WORKSHOP AGENDA

Planning Commission
January 13, 2026 @ 5:30 PM
For the January 27, 2026 Regular Meeting @ 6:00 PM

Planning Commission Report
Meeting: January 13, 2026

City of La Vergne

DRAWING NUMBER
C1.0

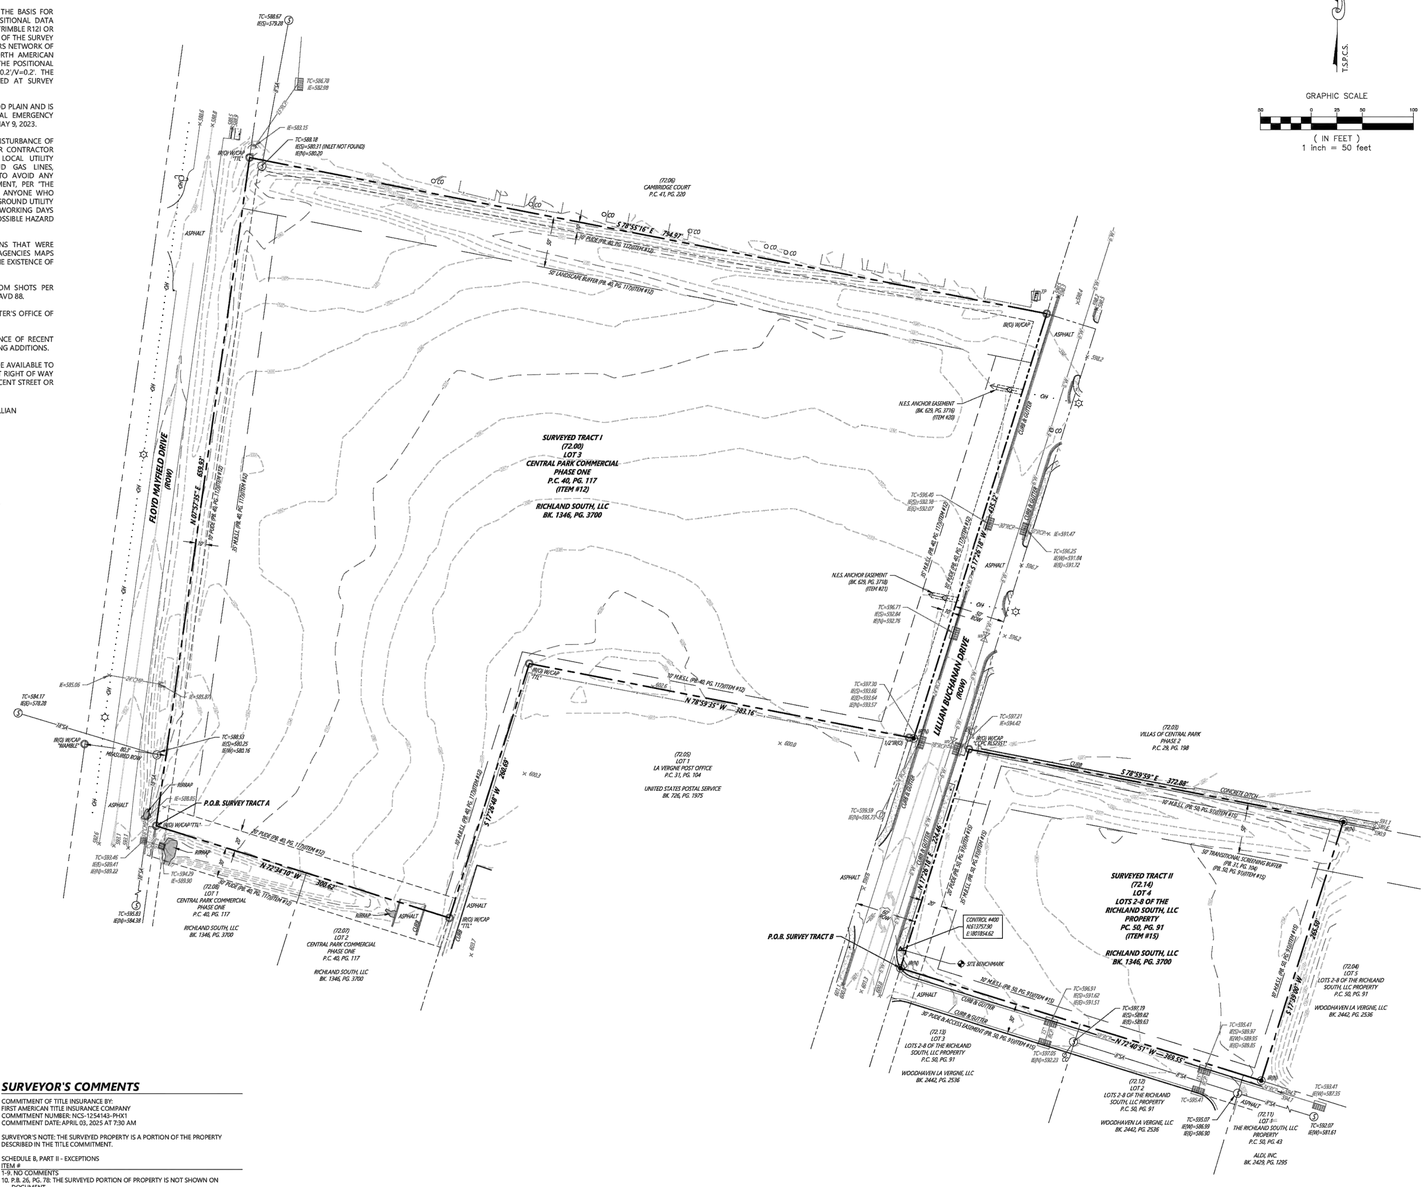
5. (Sheet C1.0) Add a finished floor elevation (FFE) for the existing condo unit closest to Floyd Mayfield drive and just north of the northwest property corner.

15. (Sheet C1.0) Show the existing fire hydrant at the northwest corner of the property.
16. (Sheet C2.0) Add the city general notes shown as G03 within the Permitting and Construction General Information and Requirements document found at the following link: https://www.lavergnetn.gov/DocumentCenter/View/4671/Permitting-and-Construction-General-Information-and-Requirements

DRAWING NUMBER
C5.1

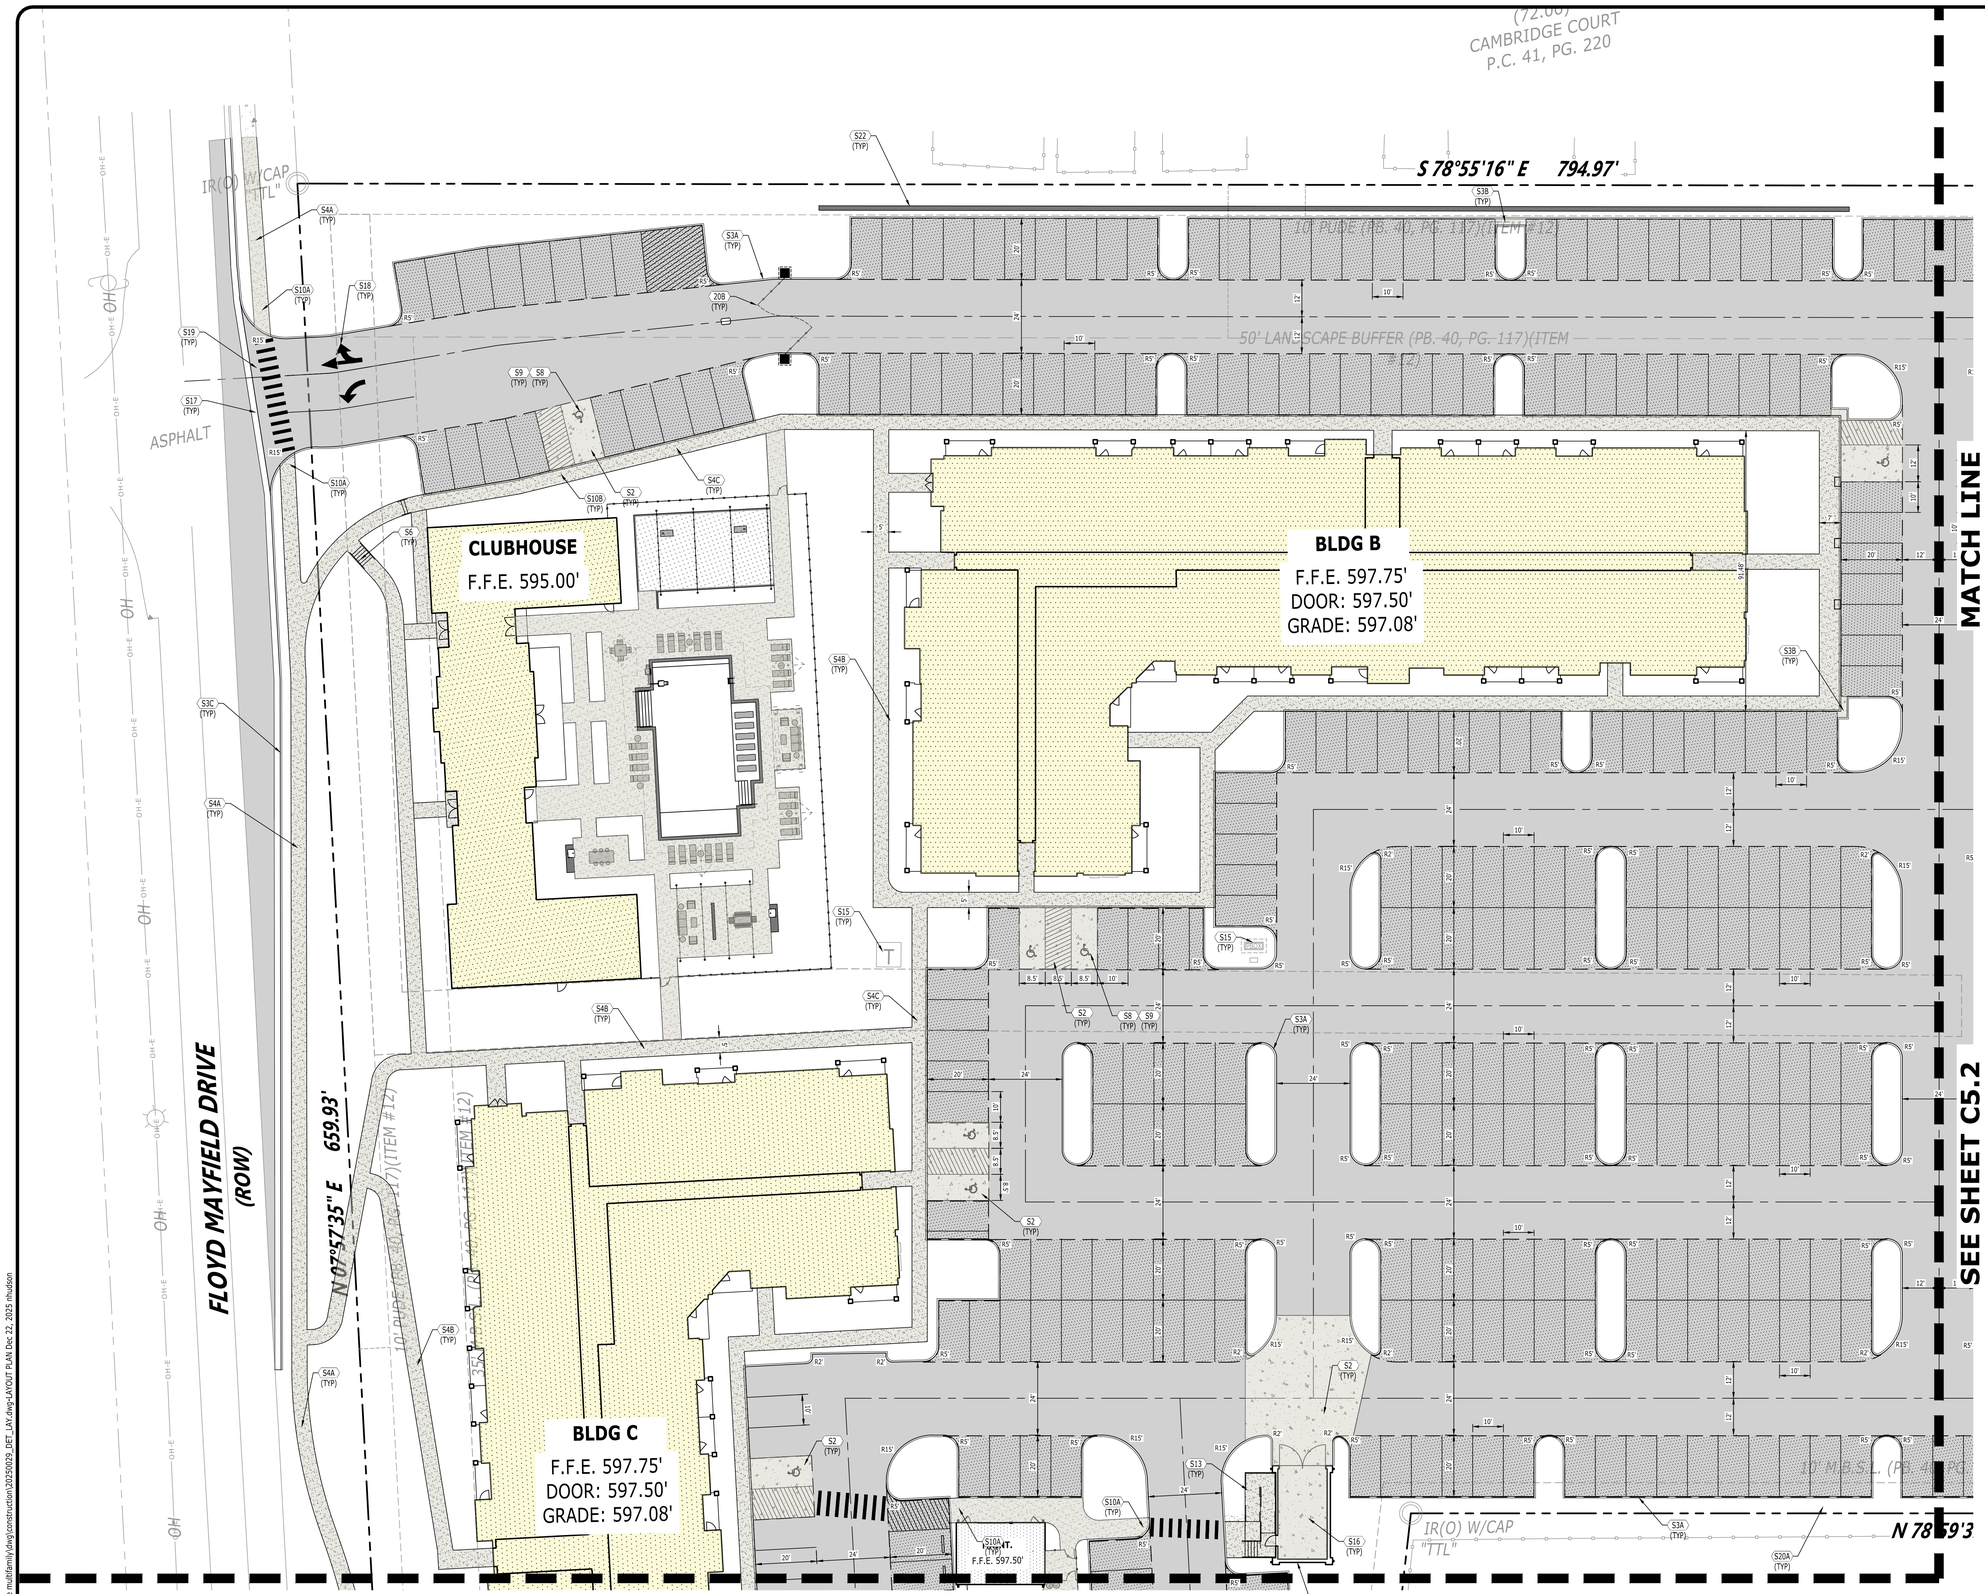
11. (Sheet C8.4) Remove references to the Inspection Ports being optional. They are required and their use should be incorporated into the LTMP.
12. (Sheets C5.1 through C5.3) Provide sufficient information to field locate each building on the site. This can be two building corners or one building corner with a bearing.

18. (Sheet C5.1, C5.2, and C5.3) Show lane widths for driveways.
19. (Sheets C5.2, C5.3, and LSP1.0) On sheets C5.2 and C5.3, notes for S20A and S20B say to “See Landscape Plans). Provide heights, materials, locations, and details for the fencing and gates as referenced. “Decorative Fencing” is insufficient for description.

20. (Sheets C5.1, C5.2, and C5.3) Show distances from edge of driveways to nearest property line.
21. (Sheets C5.1, C5.2, and C5.3) Show distances from back of curb in parking areas to nearest property line.

22. (Sheets C5.1, C5.2, and C5.3) Show dimensions for all traffic islands and curb extensions.
23. (Sheet C5.1) Show dimensions for concrete paving in front of compactor.

26. (Sheet C5.0) Show the proposed and allowed ISP in the Site Data.
27. (Sheet LSP1.0) Show locations, dimensions, and descriptions of proposed monument signs.

DRAWING NUMBER
C6.4

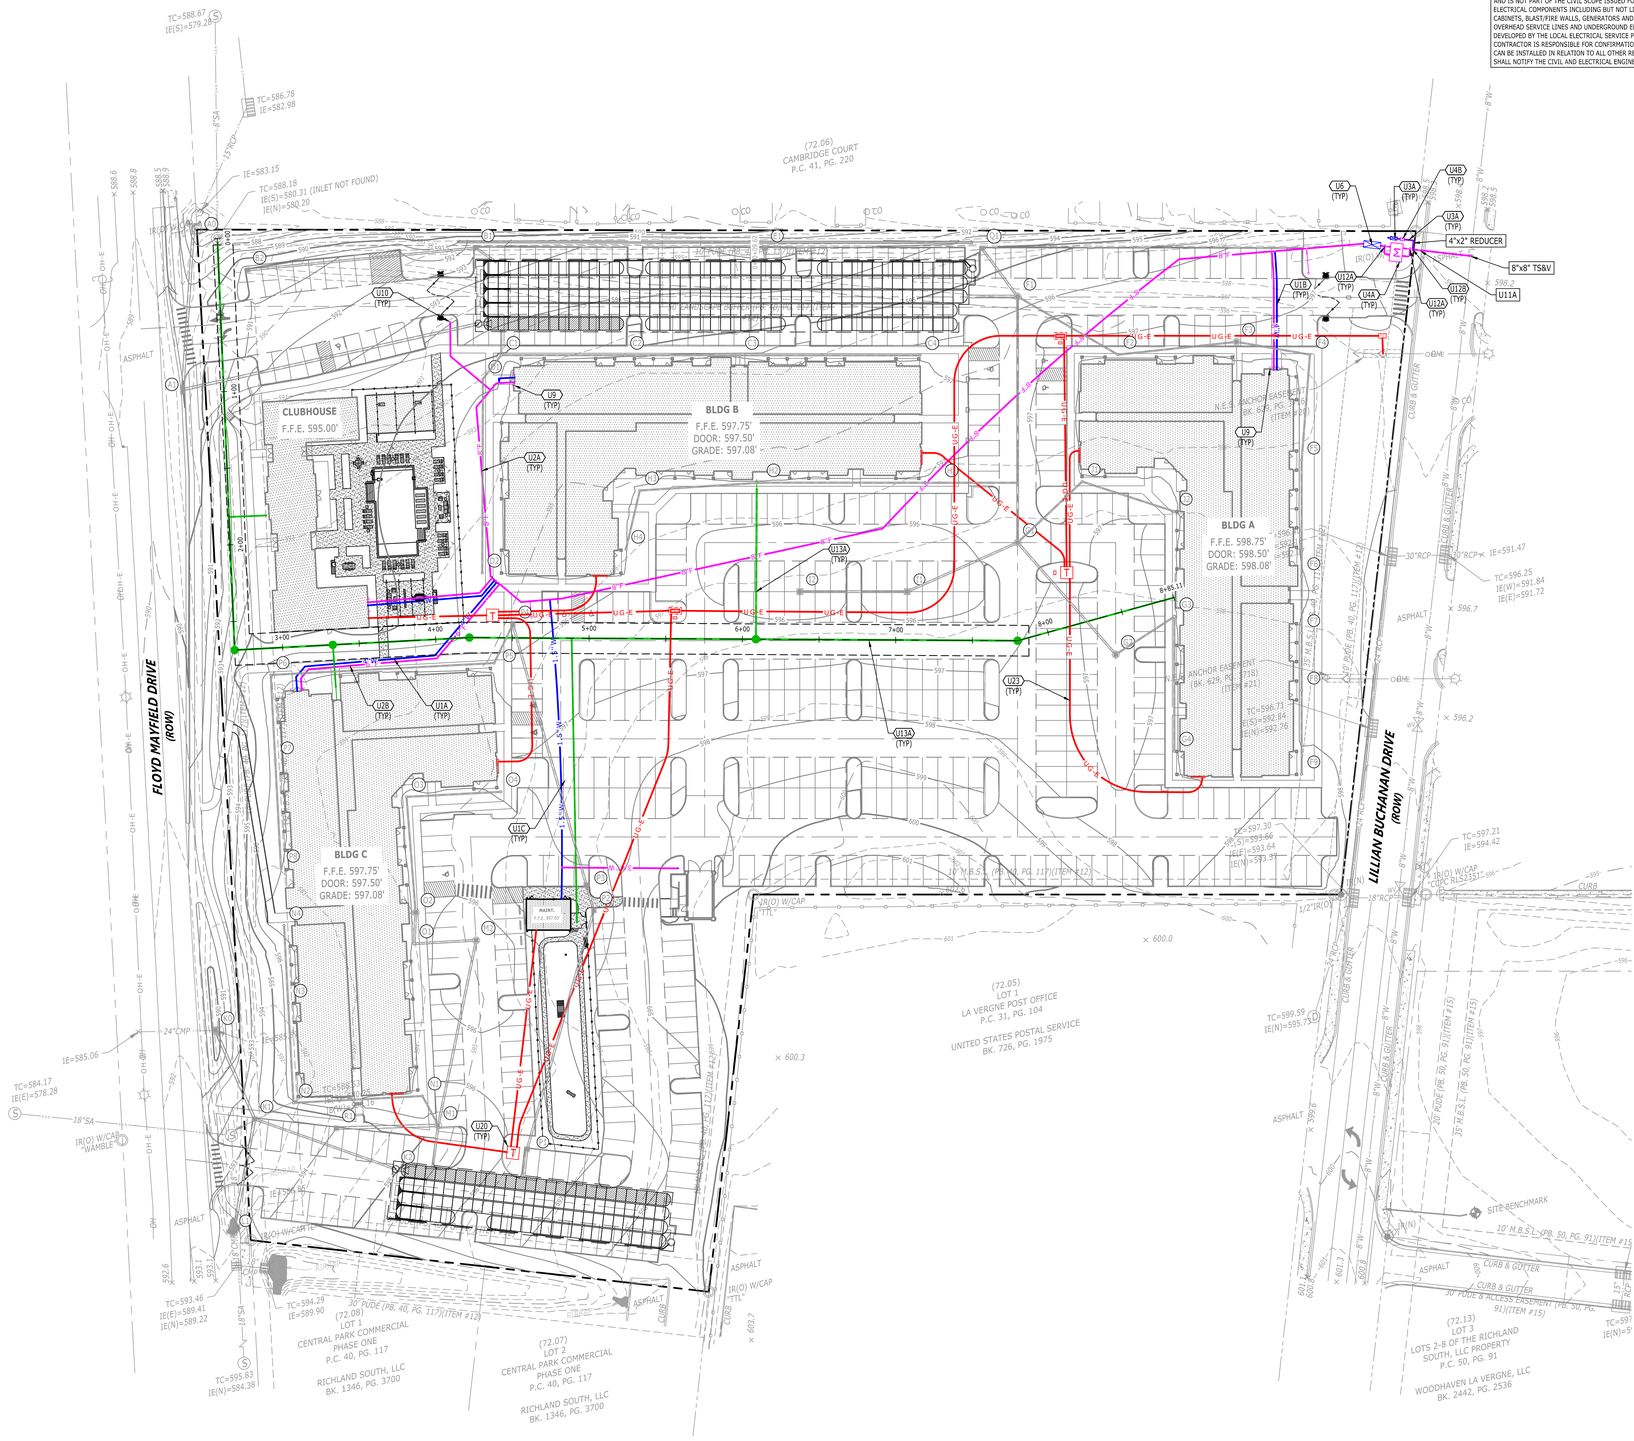
7. (Sheet C6.4) Change pipes L1 to K1 and K1 to K0 from 15” to 18” to match existing upstream pipe which is tied to them.
8. (Sheet C8.4) For both items ‘G’ (Outlet Control Structure OCS), this sheet says “Design by Engineer/Provided by Others”. Provide this design and include the rectangular orifices matching the calculations.

32. (Sheet C6.3) Provide a TC Elevation and Invert for Structure K2 and rename Structure K@ to DET2 to match tables on Sheet C6.4.
33. (Sheet C6.4) Provide size, material, and slope for Pipe K2 to K1.
